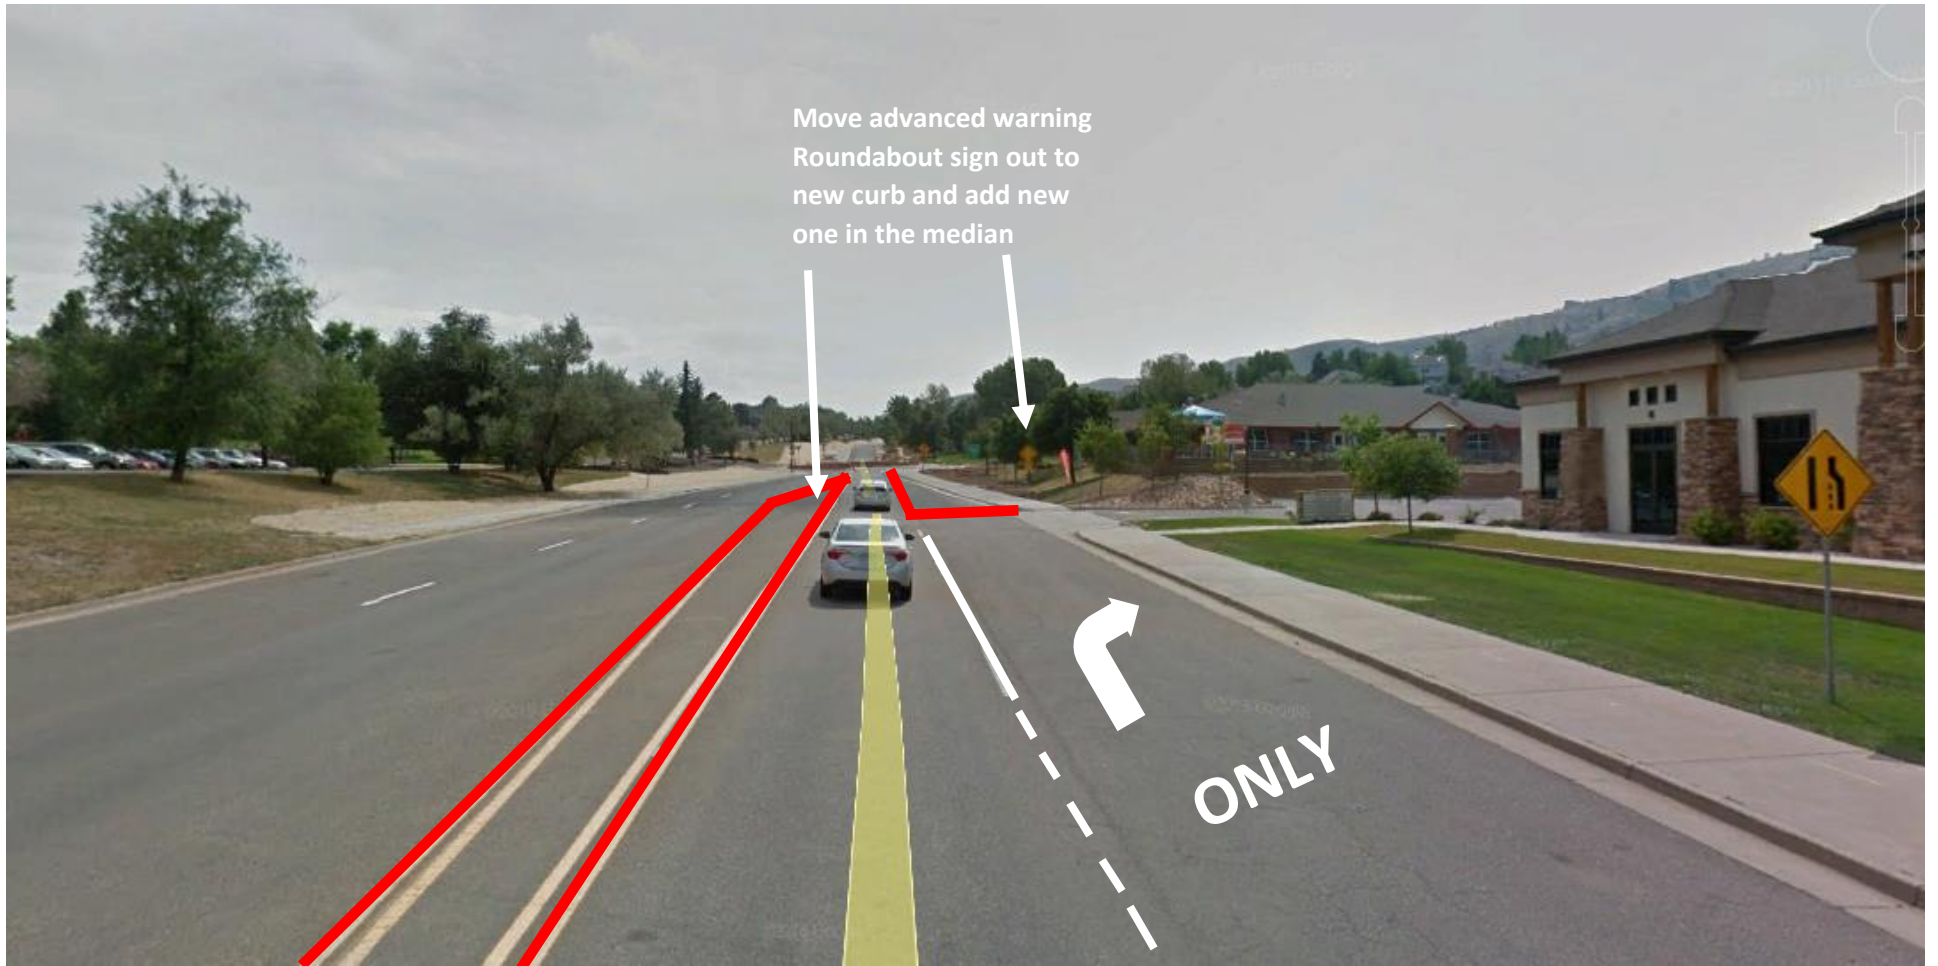
Move advanced warning
Roundabout sign out to
new curb and add new
one in the median
